UNOX System Evaluation Paul Klopping, Todd Talley, and Mike Foster Environmental Business Specialists, LLC Evaluation Dates: March 10 – 13, 2008 Report Issued: March 21, 2008

#### UNOX Wastewater System Evaluation, March 10-13, 2008

#### Clarifier #1 State Point Analysis Conditions as of March 13, 2008

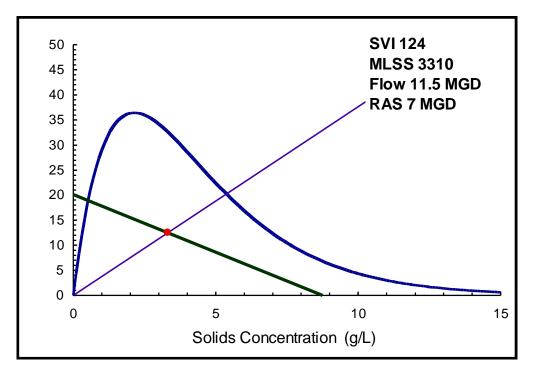
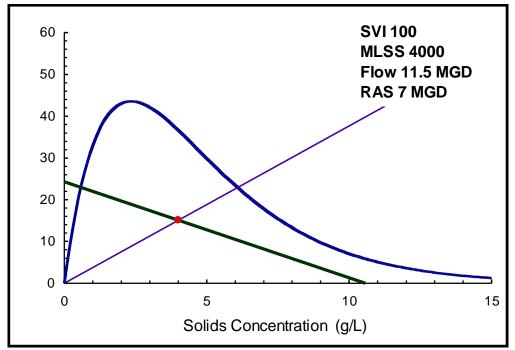
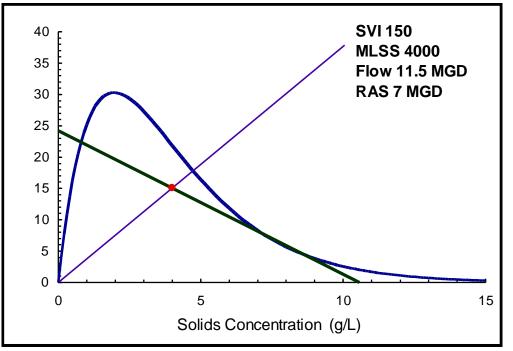
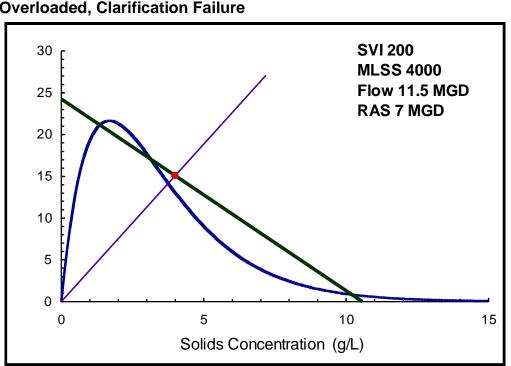
A series of clarifier state point analyses were performed to evaluate the loading and predict the performance of the secondary clarifiers. Based on your historical experience, an SVI of 150 mL/g was chosen as a realistic value that represents the settling properties of the MLSS. A range of MLSS values were then evaluated at a fixed SVI of 150 and flow rate of 11.5 MGD per clarifier.

Under these conditions, it appears that a MLSS range of 4,000-4,500 mg/L produces an acceptable clarifier solids flux (prevents the clarifiers from becoming overloaded.) I suggest keeping the MLSS in this range unless the SVI drops. The system can be operated at a MLSS of 5,000-5,500 mg/L if the SVI is 100 mL/g or lower.

State point graphs for Clarifier #1 and Clarifier #5 are included below to illustrate the effect of SVIs at 100, 150, 200 and 250 mL/g. Clarifiers #1, #2 and #3 are 180 feet in diameter, while Clarifiers #5 and #6 are 200 feet in diameter. The first set of graphs illustrates the results for the smaller clarifiers and the second set of graphs illustrates the results for the larger secondary clarifiers.
